Hoskins • Western • Sonderegger, Inc.  
 PO Box 80358 825 J Street  
 Lincoln, Nebraska 68501  
 402/475-4241

REFERENCE: EPA Aquifer Exemption Hearing for Uranium Mining Permit  
 Application for Wyoming Fuel Company

This letter is to provide comments for the EPA hearing to be held June 21, 1984 in response to the exempted aquifer petition submitted by Wyoming Fuel Company.

FIGURE 2

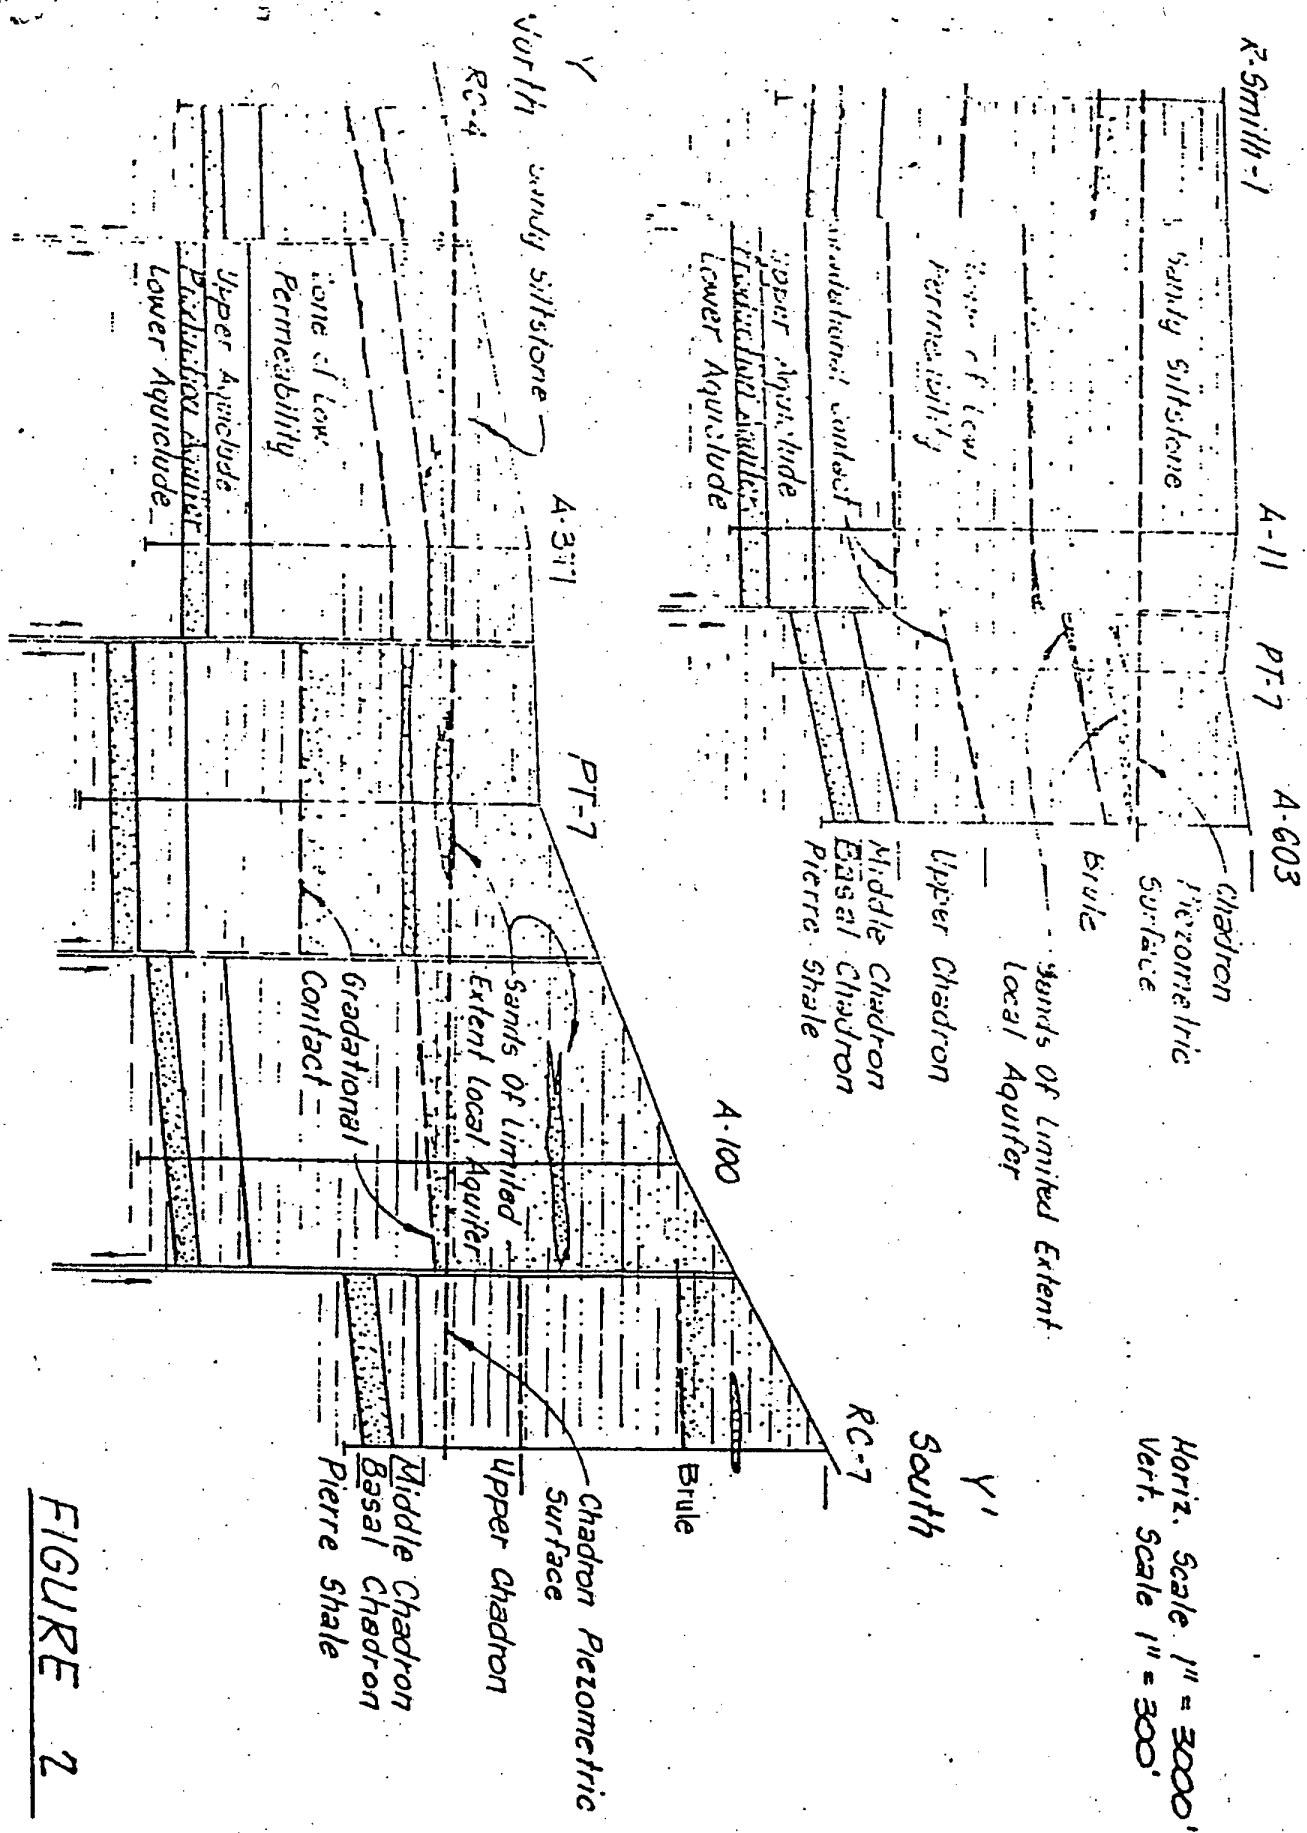
3. Wyoming Fuel has not shown that the lower Chadron is a separate unit of the Regional aquifer which includes the Chadron and the Brule. If the lower Chadron is hydraulically connected with the Brule, any injection would "endanger drinking water sources" which is a violation of Title 40, Chapter 1, Subpart A, 144.1(e).

We have prepared an alternate geologic interpretation (Figures 1 and 2 of this letter) based on the Wyoming Fuel data submitted in the exemption petition. The alternate interpretation is a physical model which includes faults to explain changes between bore holes. Faults are known to occur in the region in connection with springs. Thus the fault fractures play an important role in the flow system by providing upward movement along faults. The best example of this is the large spring (1,000 GPM) at Fort Robinson State Park located about 6 miles west of Boring numbered PT-7. Numerous smaller springs occur in the area northwest to northeast of Boring numbered PT-7. It is possible that the disruption of groundwater flow by faulting caused the uranium ore to be deposited in the first place.

The burden of proof is on the mining company to show that the Lower Chadron is isolated from the remainder of the Regional Aquifer. The pump test was of limited scope. It would prove isolation of the Lower Chadron only out to a distance of 1 mile from the tested well. It is possible that the proposed Research and Development area is situated on one isolated fault block. Under this condition it would meet the criteria.

Additional pump tests of longer duration and over extended areas are needed to map the extent of the isolation of the Lower Chadron. Geophysical prospecting can detect zones of fractures. Angle-drilled holes across suspected fractures could provide locations for in-place permeability tests which could show the existence of vertical permeable zones which would connect all the geologic units into one aquifer.
